# HISTORIC AND DESIGN REVIEW COMMISSION

**HDRC CASE NO:** 2017-467  
**ADDRESS:** 423 N HACKBERRY ST  
**LEGAL DESCRIPTION:** NCB 576 BLK 15A LOT N 30.32 FT OF 12  
**ZONING:** RM-4 H  
**CITY COUNCIL DIST.:** 2  
**DISTRICT:** Dignowity Hill Historic District  
**APPLICANT:** John Brearley  
**OWNER:** John and Irene Brearley  
**TYPE OF WORK:** New construction of a 2-story single family home  
**REQUEST:**

The applicant is requesting conceptual approval to construct a new two-story single family home on the vacant lot at 423 N Hackberry St.

ADDRESS: 423 NORTH HACKBERRY ST.

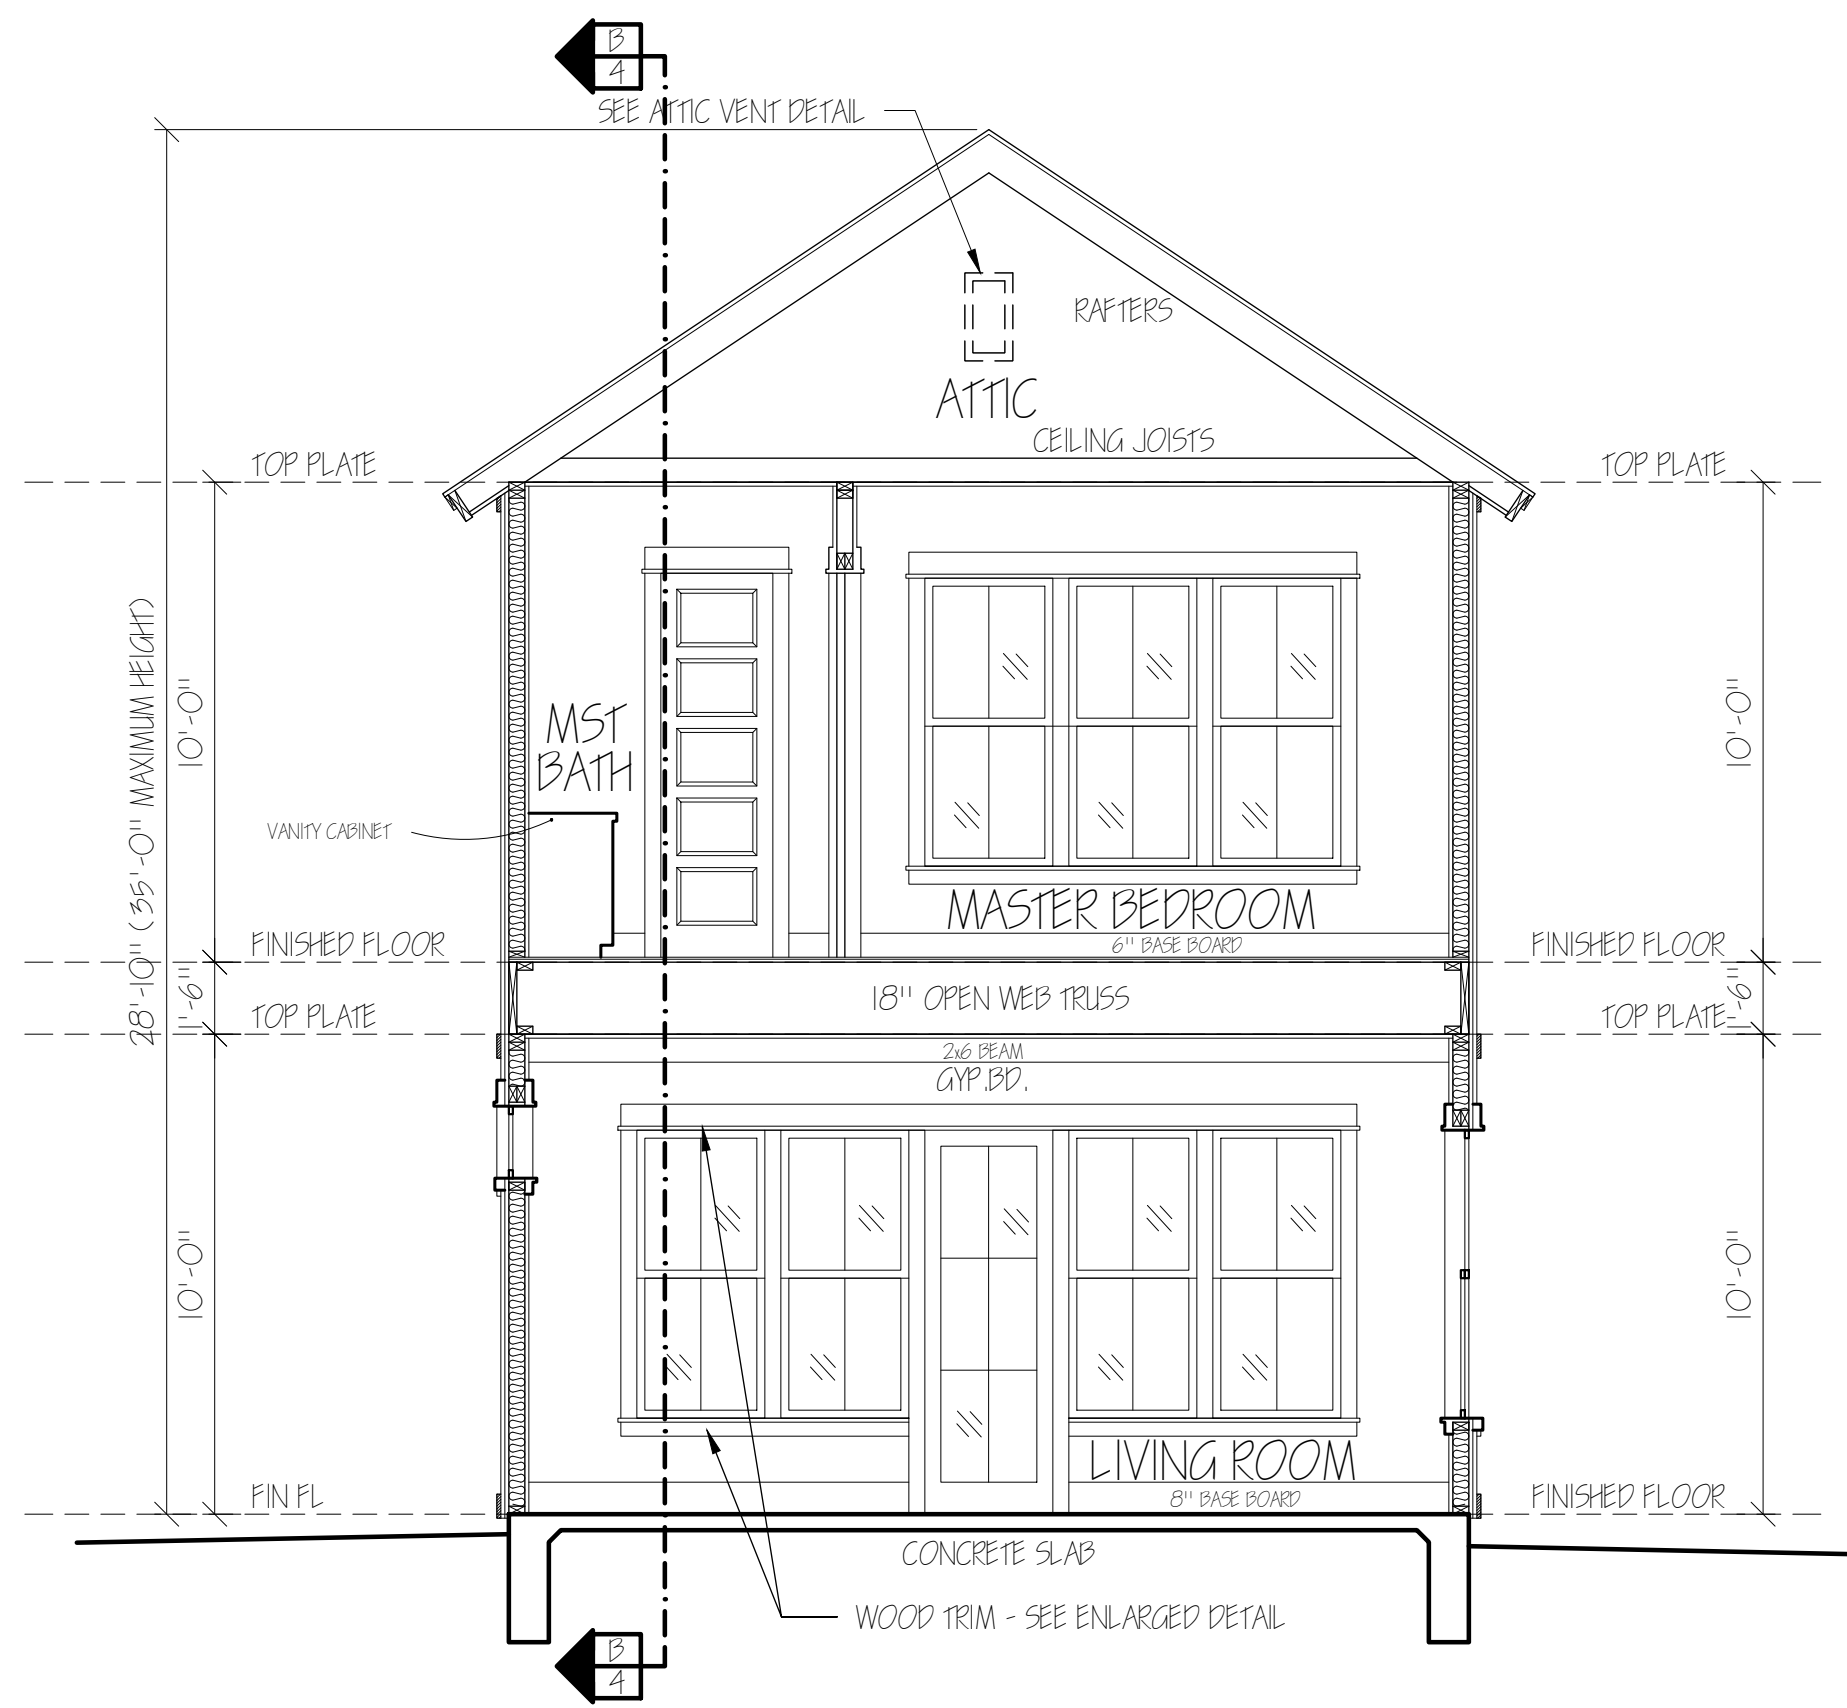
- f. **SCALE & MASS** – Per the Guidelines for New Construction 2.A.i., a height and massing similar to historic structures in the vicinity of the proposed new construction should be used. In residential districts, the height and scale of new construction should not greatly exceed the historic precedent. The only remaining historic residential structure on N Hackberry between E Houston and Glorietta is 2 stories. The remaining historic structures in the vicinity on Glorietta are 1-story. The applicant has noted on the submitted drawings that the proposed ridge line will be 28'-10" from the finish floor, which is approximately one foot from grade, bringing the total height to approximately 29'-10" feet. Both the first and second stories will feature 10'-0" tall interior ceiling heights separated by a web truss measuring 1'-6". The neighboring 2-story historic structure features a first floor ceiling height of 10'-0" and a second floor ceiling height of 8'-0". Staff does not find the proposed height to be consistent with the Guidelines. Staff finds that the overall height should be reduced through the shortening of the second story or the lowering of the top plate height to produce an overall height that is comparable with the heights of neighboring, historic structures.

- g. **PORCH CONFIGURATION AND MASSING** – The applicant has proposed to incorporate a front porch on the front façade of the new structure. The porch mass will be inset approximately 6" from the front façade. The Historic Design Guidelines state that porches on new construction should be reflective of the development pattern of the district. Typically in historic districts, including Dignowity Hill, residential porch massing elements project the furthest towards the streetscape to engage pedestrians. Two story structures feature a second story that is set back from the porch. As proposed, the structure's second story extends over the front porch, which increases the massing on the street. This is addressed in Guideline 2.A.ii, which states that step-downs in building height, wall-plane offsets, and other variations in building massing to provide a visual transition should be utilized. There is no historic precedent in the district for this porch form or massing strategy. Staff finds the porch inconsistent with the Guidelines.

- h. **FOUNDATION & FLOOR HEIGHTS** – According to the Guidelines for New Construction 2.A.iii., foundation and floor height should be aligned within one (1) foot of neighboring structure's foundation and floor heights. The applicant has noted that the foundation will be slab-on-grade and have a minimal height. Historic structures on this block feature foundation heights of approximately eighteen (18) to twenty-four (24) inches. This is generally inconsistent with the Guidelines and the surrounding context.

- j. **WINDOW & DOOR OPENINGS** – Per the Guidelines for New Construction 2.C.i., window and door openings with similar proportions of wall to window space as typical with nearby historic facades should be incorporated into new construction. The applicant has proposed window and door openings that are generally consistent with those found on historic structures in regards to location and size with the exception of the right and left elevations, which feature several small fixed windows that are not consistent with the OHP Window Policy Document or historic fenestration precedents in the district, as well as a series of ganged windows with minimal trim separation between them. All proposed window detailing can be modified to relate closer to historic examples, such as the use of approximately six inches of separation between double windows. Each window should be inset at least two (2) inches within walls to ensure that a proper façade depth is maintained.

1. That the applicant provides information noting the setbacks of adjacent historic structures on a contextual site plan.
2. That the applicant reduces the proposed height through the shortening of the second story or the lowering of the top plate height to produce an overall height that is comparable with the heights of neighboring historic structures.

3. That the applicant sets the second story back from the front façade and modifies the front porch configuration and massing as noted in finding g. The porch should be the mass that projects furthest towards the streetscape to reflect the developmental context of the area.

4. That the applicant explores ways to incorporate a raised foundation for a front porch or pedestrian entry to be more consistent with neighboring historic structures as noted in finding h, if feasible.

5. That the applicant explores ways to construct a driveway along the side of the proposed new construction as noted in finding p.
6. That the applicant introduces window sizes and proportions that are more consistent with the Historic Design Guidelines, the OHP Window Policy Document, and adjacent historic structures to the right and left elevations as noted in finding i.
